Evaluation of Bus Management Options For Independence National Historical Park

Final Report
July 6, 2000

Prepared for
National Park Service
Northeast Region
200 Chestnut Street
Philadelphia, PA 19106

Prepared by:
John A. Volpe
National Transportation
Systems Center
Kendall Square
Cambridge, MA 02142

Figure 2.2.1. Option 1 - Saw Tooth Berth Arrangement

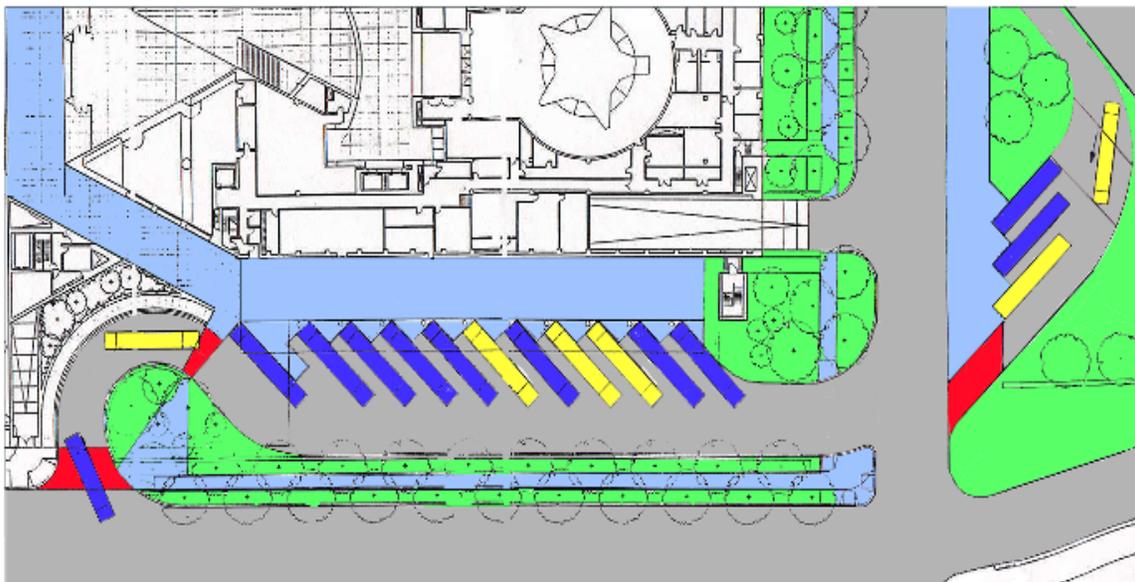
The estimates of Option 1 capacity, however, appear to be overly optimistic, based on the operational plan associated with this option, which calls for each bus to first access the stacking area on Race Street (see Figure 2.2.2 on the following page) before proceeding to a saw tooth berth, unless pre-authorized by a bus controller or the ITC manager to proceed directly to a berth. The operational complexity of this option is discussed in detail in Section 2.2.5. The three DRPA Bridge Triangle spaces are estimated to accommodate nine buses per hour by the proposers. This means that the 14 berths will actually function like 12 berths, putting the system in overflow at demand above 40 bus arrivals per hour (with 10 minute average dwell time). Since actual dwell times for drop off will be significantly shorter than for pick up (e.g. 8 minute dwell time), the “12” berths will likely handle most drop offs under current demand, except during morning peaks on spring weekdays (10-11:00 A.M.).

The three DRPA Bridge Triangle berths would not be available for unloading, since they are not accessible once a bus has entered the stacking lanes. This reduces their effectiveness considerably. Attempting to schedule bus arrivals at these berths will not function as planned, due to traffic and other delays that will inevitably occur. If the controllers schedule three buses to arrive at a specific time and three others to arrive 20 minutes later⁶ in the anticipation that the first three will have departed, there will be occasions when all six buses show up at the same time. There is no room to accommodate buses stacking at the DRPA Bridge Triangle, so these buses will either have to exit the DRPA Bridge Triangle without stopping or stack up in traffic flow areas. This will require a fifth controller location, as well, to take information from scheduled arrivals and direct traffic through the DRPA Bridge Triangle.

Figure 2.2.2 Option 1 - Stacking Spaces for six Buses on Race St.

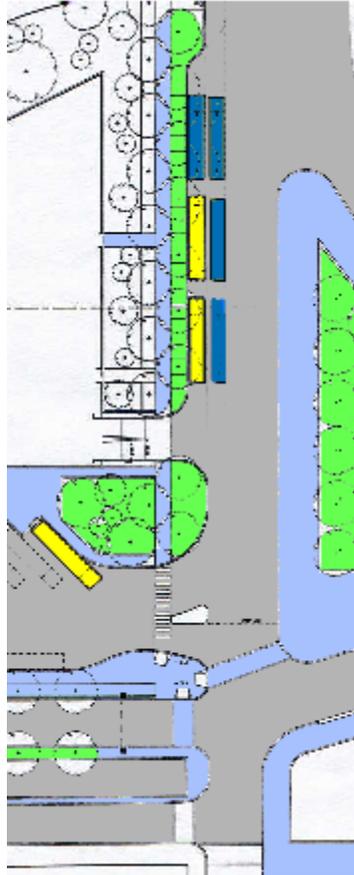
The 7 or 8 overflow spaces on 5th Street will not function properly during overload conditions. This layout requires parallel parking operations for buses pulling into or out of these spaces on the city street. To allow for appropriate turning movements into and out of a curbside space in through traffic conditions at 20 mph, a minimum of 175 feet is needed for a 45-foot bus. Therefore, a maximum of two overflow spaces can fit into the proposed 5th Street area. From the existing bus arrival numbers, the overflow spaces will be full, necessitating drivers to fend for themselves more than 12 % of the time during spring weekdays between 12:00 – 1:30 P.M., as overflow of these spaces is not addressed in the operations plan.

Buses are assumed by the ORA operation plan to be entering Race Street from the 6th Street highway exit⁵. This requires buses to cross both lanes of Race Street traffic to get into the stacking area in a short distance. Since this area will be in overflow continuously, buses will be stopped on the exit ramp and on Race Street waiting to enter the stacking lanes. As drivers learn that this is a problem, more and more of them will probably find alternative places to drop off and/or pick up passengers, effectively undermining the operations plan.

Figure 2.3.1 Option 2 – 16 Saw Tooth Berth Arrangement in Underground Facility

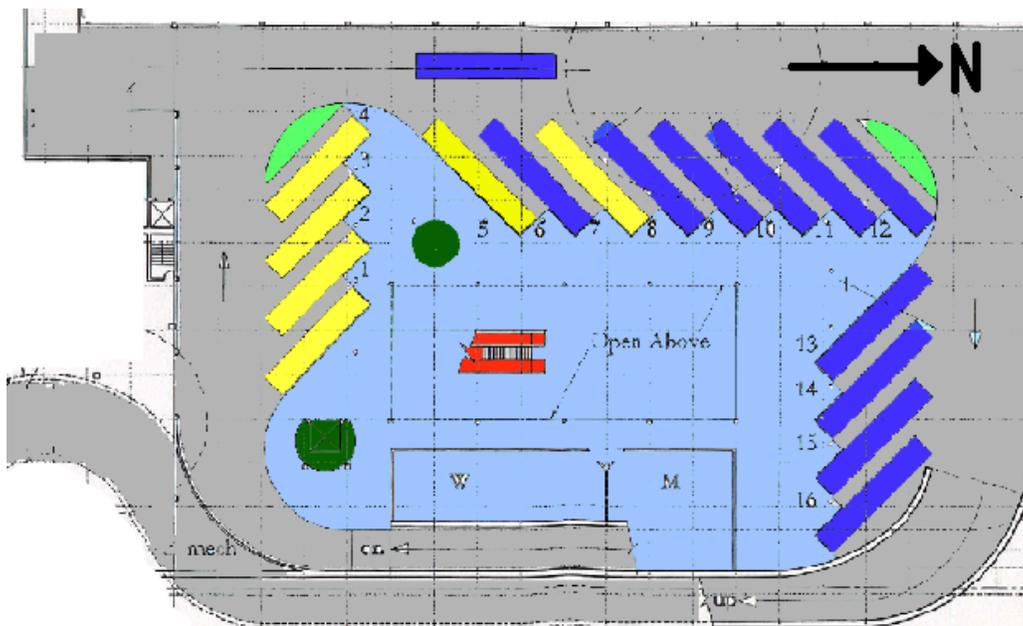
In the event of a detection (see above), exhaust fans should be automatically operated, in conjunction with vents, louvers, etc., to provide adequate ventilation to effectively eliminate pockets of methane that can reach the lower flammability limit. The proposed design includes forced ventilation, but does not address stagnant pockets. Additionally, all fans, blowers and other equipment should be National Electric Code Class 1, Division 2 certified, since they will be operating in a gas rich environment in the event of a leak.

All spark-generating equipment should be de-energized in the event of a leak. All electrical equipment in the travel path of the gas-rich air should be investigated and appropriate measures taken to eliminate, relocate or replace it with appropriate equipment. The National Fire Protection Association’s NFPA 52 and applicable parts of NFPA 70 should be adhered to.

Detection of methane should, in addition to energizing ventilation, automatically sound appropriate audible alarms; display visual alarms and summon necessary personnel at the facility and from appropriate emergency response agencies, such as police and fire.

the facility. This may be adequate for ambulatory patrons (redundancy of escalator and stairways), but may be inadequate for a sizeable expected population of patrons using mobility-aids (which is probable given that this is a tourist site). A bank of elevators may be necessary, and it is not clear whether the design can be modified to include the extra core space needed for a bank of elevators.

Figure 2.4.1. Option 3A - Saw Tooth Arrangement of 16 Berths

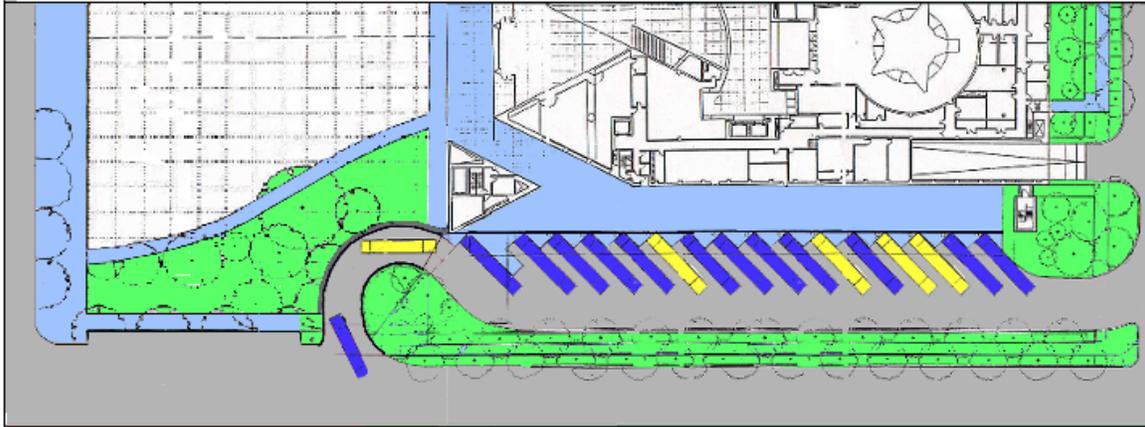
An adverse impact of Option 3A would be the encroachment into the landscaped area in the southwest corner of the NCC site, resulting from the expansion of the bus facility footprint. The bus turnout to 5th Street would be visible from the terrace and park areas, whereas in other options the bus facility would be shielded from view by the NCC structure. This can be mitigated through construction of a “designer” wall structure that would effectively provide separation.

Figure 2.5.1. Option 3B Saw Tooth and Parallel Berths

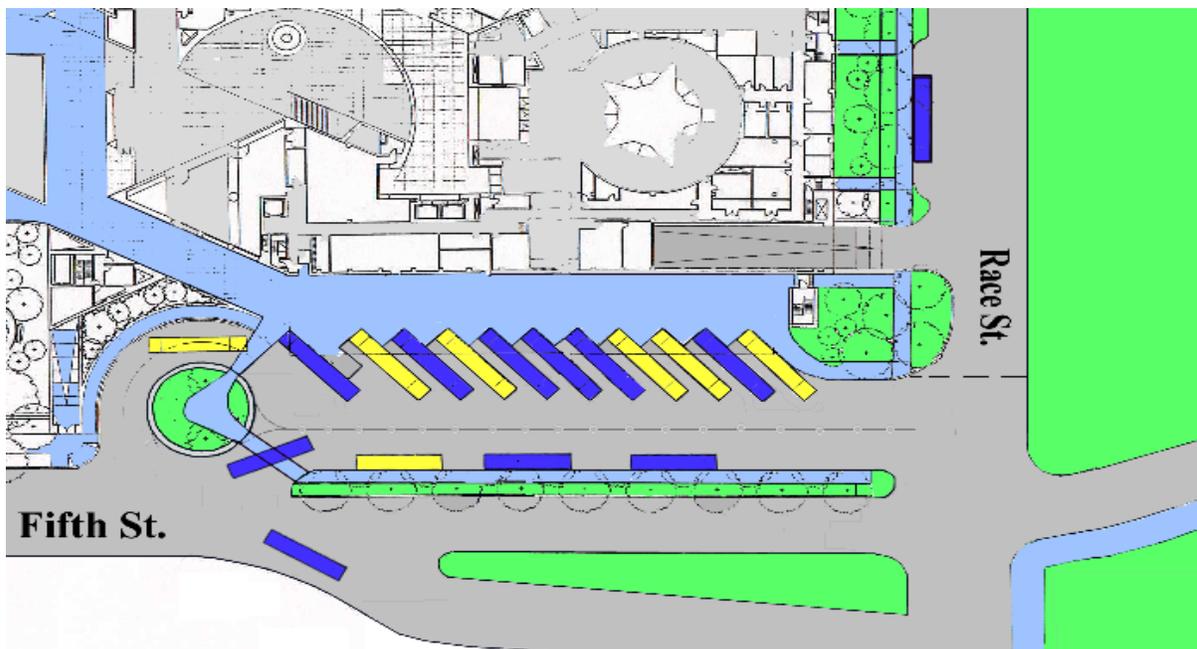
There is a section of 12.75% grade per the architect's newest drawing at the return entrance into the south end of the ITC lot. Based on the configuration and bus dimensions, this grade presents a potential problem for buses returning into the lot when all saw tooth berths are full. Further analysis by Pennoni Associates, transportation engineers contracted by Pei Cobb Freed & Partners, shows that buses would have to depart on 6.2 percent downgrade and immediately enter on a 12.75 percent upgrade potentially creating a "roller coaster effect."

Since there is not enough room for independent backing maneuvers of opposite buses from the saw tooth berths and the three quasi-berths a Bus Controller would have to provide manual direction to minimize the potential conflicts.

existing traffic stop line be moved westerly on Race Street to the western edge of the ITC entrance. To safely exit buses, the signal at 5th and Race can be modified to include a delay between 5th Street red and Race Street green to allow exit of the buses. Remembering that there will be perhaps 48 buses total exiting this way during non-peak through traffic times on Race Street, either the bus controller stationed at the ITC entrance/exit or a hired police officer could assist the buses to safely exit onto Race Street. This translates to an average of nearly 2 minutes between buses exiting onto Race Street under worst-case existing conditions, so a third phase is not needed in the Race and 5th Street controller.

Figure 2.7.1. Option 4 (Revised) – Deep and Shallow Saw Tooth Berths

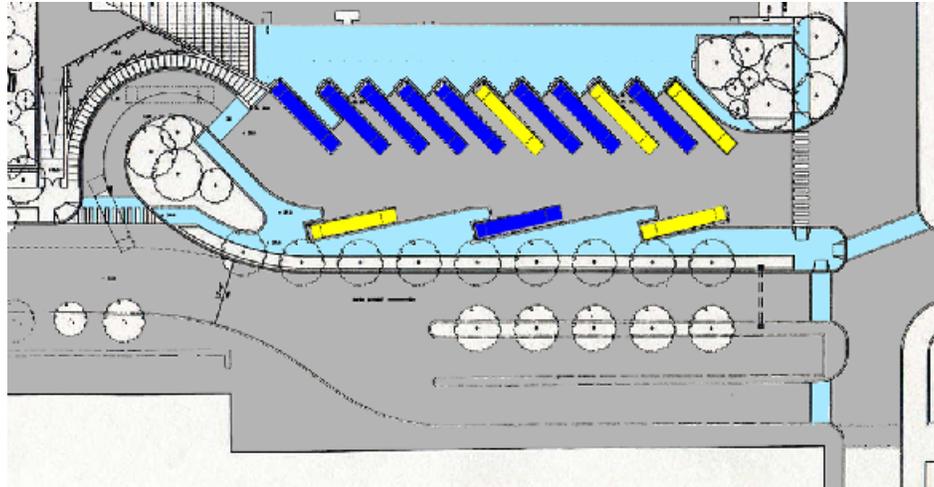
Despite moving the island platform 26’- 4” eastward, with additional width added to the central aisle, the eleven (11) deep, saw-toothed bus berths and the three (3) shallow, saw-toothed bus berths operate as less than an equivalent number of berths (14) if sited to

provide complete independence of entry and exit. This is because the common aisle, at the resultant width of approximately 29 feet, is still too narrow to allow independent movement or to prevent encroachment by maneuvering buses. Assuming operation of a simplified bus management and control system involving a FCFS regimen, however, the three (3) shallow, saw-toothed bus berths on the eastern edge of the ITC facility should be used relatively infrequently. This would be during overflow conditions only (primarily, spring weekdays) when the “primary bus facility” consisting of the Race Street berths, and the eleven (11) berths adjacent to the NCC are all occupied.

Based on the scale of the PCF&P revised schematic drawing (Drawing No. SKA-101A, 1/17/00), it looks like the loading island serving the proposed three (3) shallow saw-toothed berths is 20 ft. In other words, with shifting of this island eastward, PCF allocated 10 additional ft. to the loading island, and 6 additional ft. to the central aisle.

As mentioned above, the central aisle is still too narrow to permit complete independence of operations between the group of eleven (11) and the group of three (3) bus berths (approximately 39 feet in the central aisle is needed for complete independence). There could be conflicting backing maneuvers under the current or even proposed modified design. Some of these would occur with one or the other or both buses within the blind spot zone. Bus controllers would have to carefully control the operation.

Based on these recommendations, Option 4 as revised now incorporates two (2) bus berths (rather than three), each approximately 90 ft. each, sited on the southern edge of Race Street. This revision permits independent entry and exit for each, in conjunction with the protected access lane adjacent to these two berths. Locating two (2) bus berths is workable and operational with the proposed design modification. The two berths could also be reserved for buses with a known ADA requirement.
